22 May 2015

Subject: Comments on United Heckathorn Superfund Site Draft Focused Feasibility Study (FFS)
EPA #: CAD981436363

On behalf of Levin-Richmond Terminal Corp. and Levin Enterprises, Inc. (LRTC), Haley & Aldrich, Inc. and Weiss Associates have prepared the following comments on the *Draft Focused Feasibility Study, United Heckathorn Superfund Site*, Richmond, Contra Costa County, California, prepared by CH2MHill on behalf of the U.S. Environmental Protection Agency (EPA), February 2015, referred to herein as the "Draft FFS."

FIGURE A

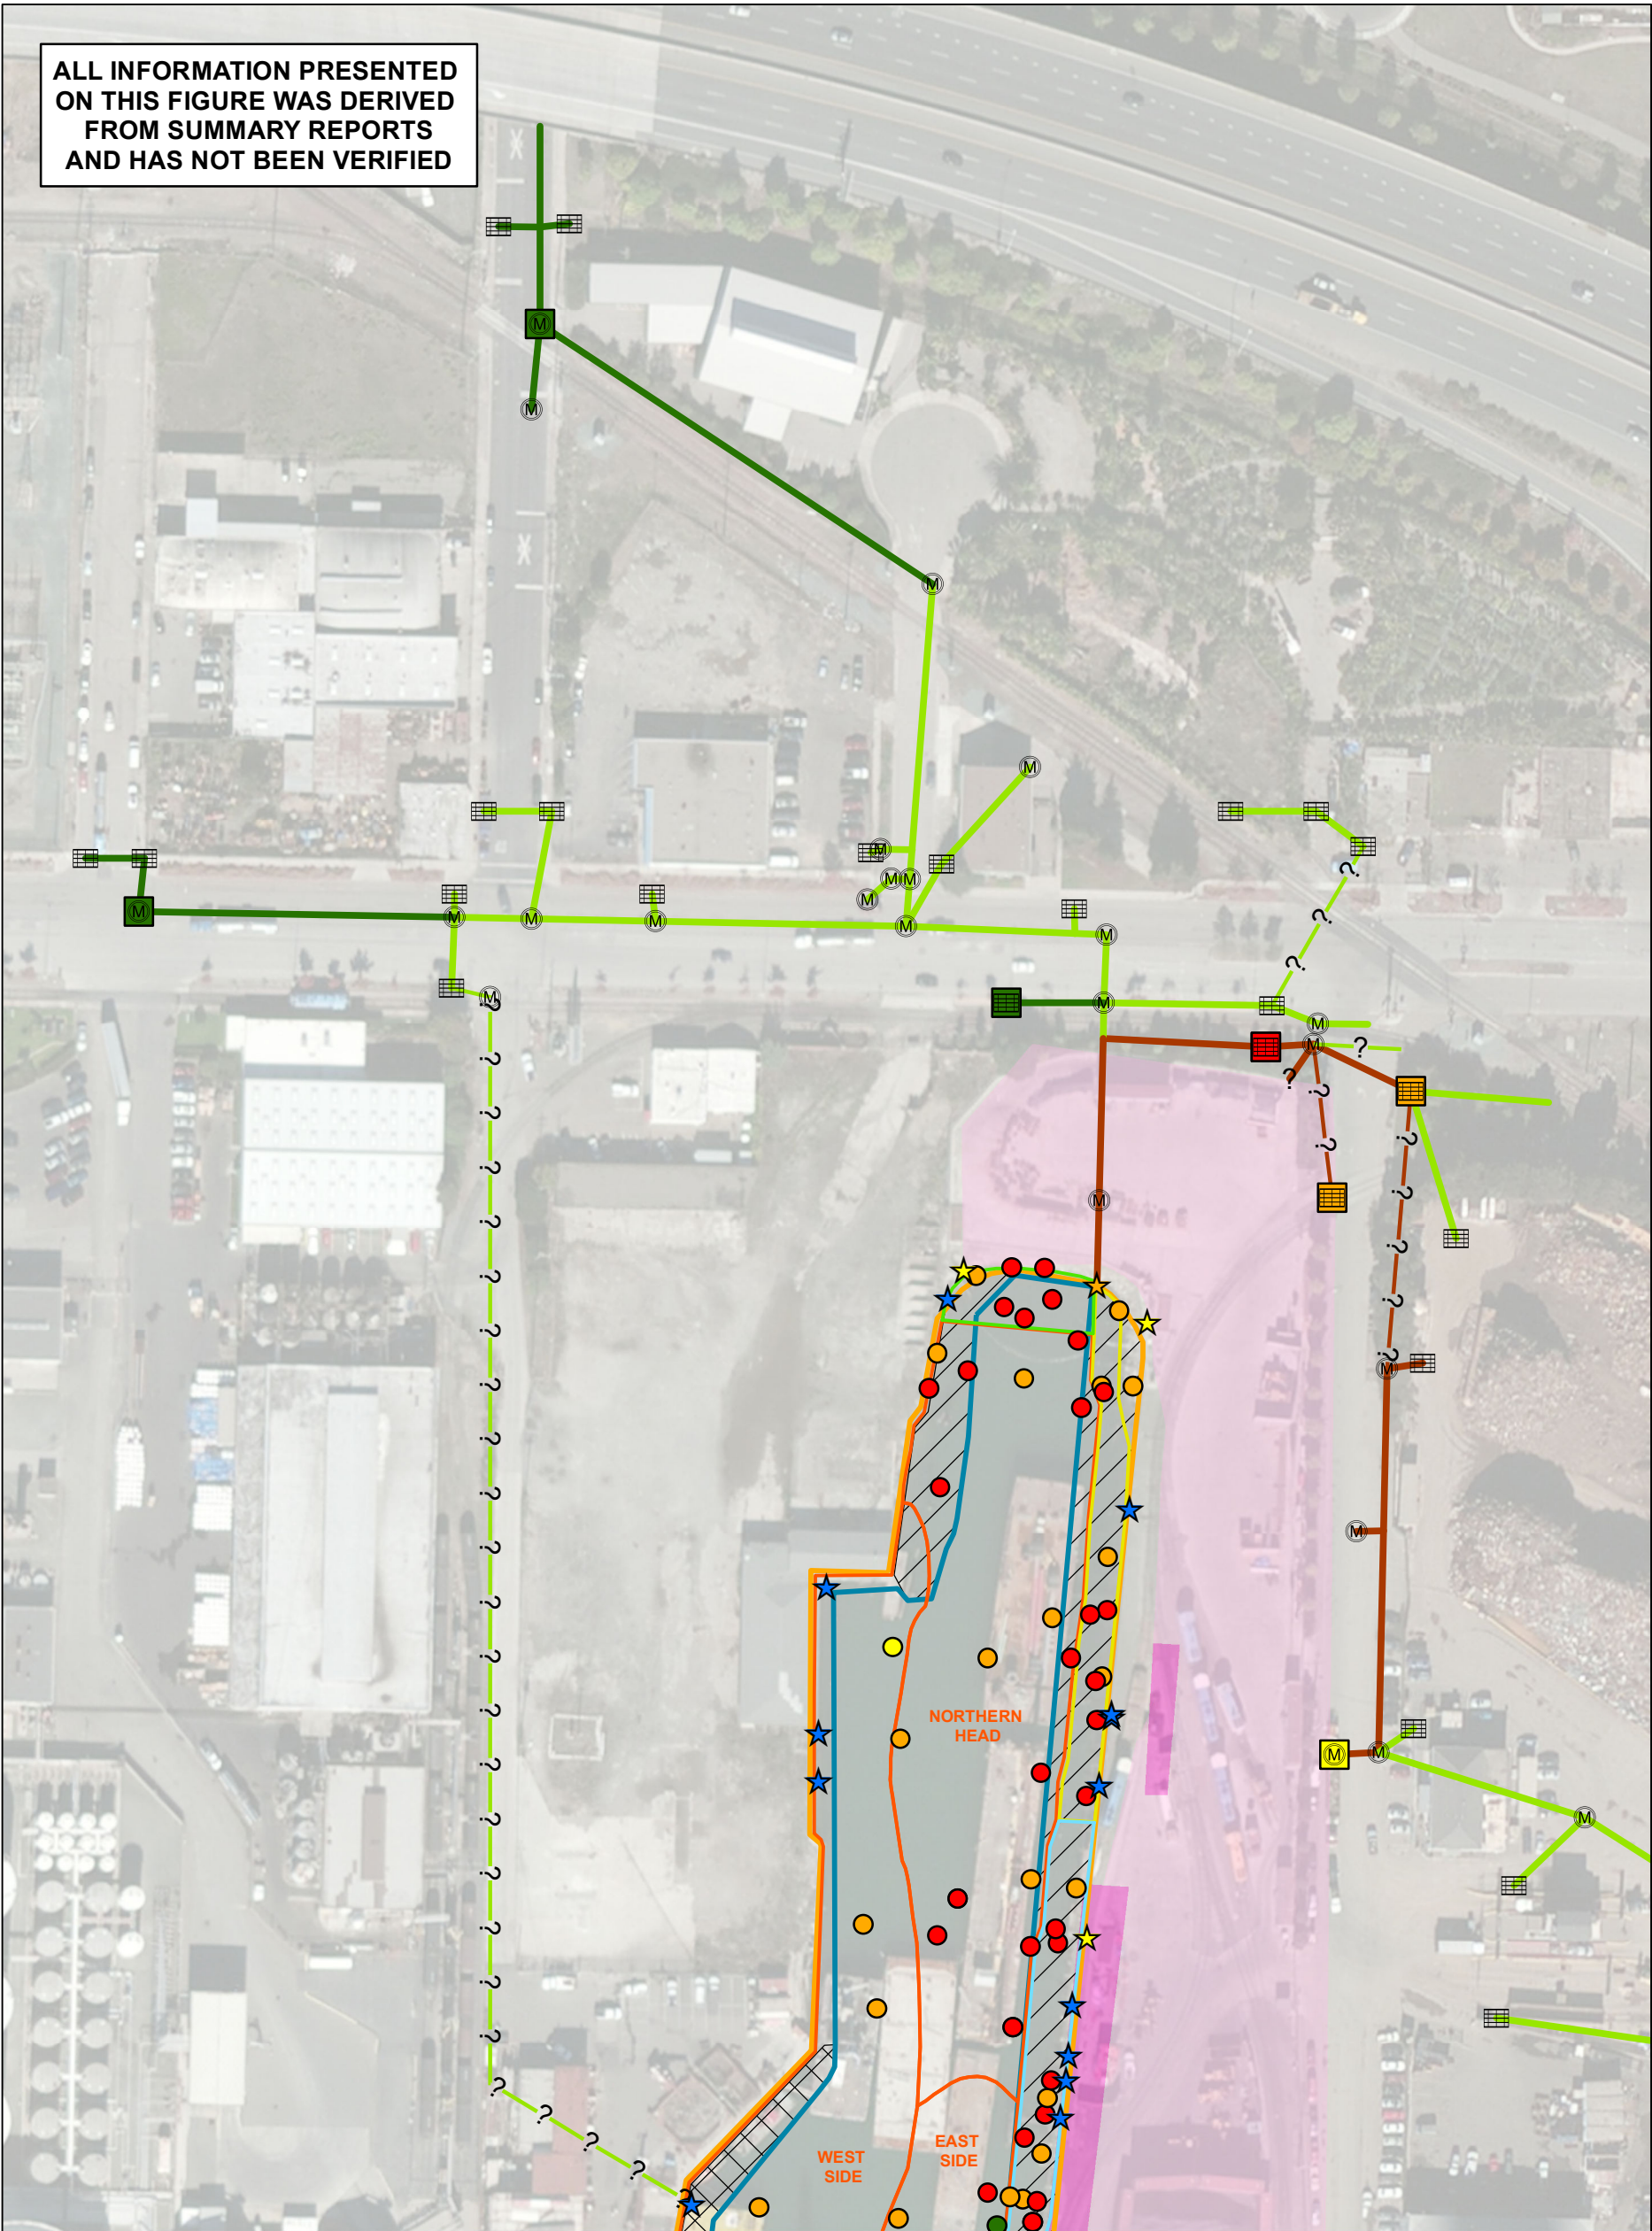
DDT is highly hydrophobic and, therefore, sorbs to particulates rather than dissolving in water. For this reason, samples of stormwater solids provide the best means of identifying portions of the stormwater system that have the potential to discharge DDT-contaminated particulates to the Lauritzen Channel. Figure A shows the municipal stormwater system as depicted on SIS Figure 6-1. Results from the limited sampling of stormwater solids (as reported in SIS Figure 6-2) are shown as colored squares. Three stormwater solids samples exceeded the proposed RG of 400 µg/kg, and a fourth was approximately 70% of the proposed RG. These samples define the portion of the system with demonstrated DDT impacts (shown in dark orange on Figure B). Three other stormwater solids samples had little or no DDT, demonstrating that portions of stormwater system are unimpacted (shown in dark green on Figure A).

Either additional storm water solids samples should be collected, or all lines shown in dark red and light green should be included in the cleaning program. Before remediating the Lauritzen Channel, these lines should be cleaned and then resampled after a significant storm event to demonstrate that the municipal stormwater system is not an ongoing source of contamination. If the system cannot be adequately cleaned, an end-of-pipe control should be considered to ensure that DDT-contaminated particulates are not discharged from the system.
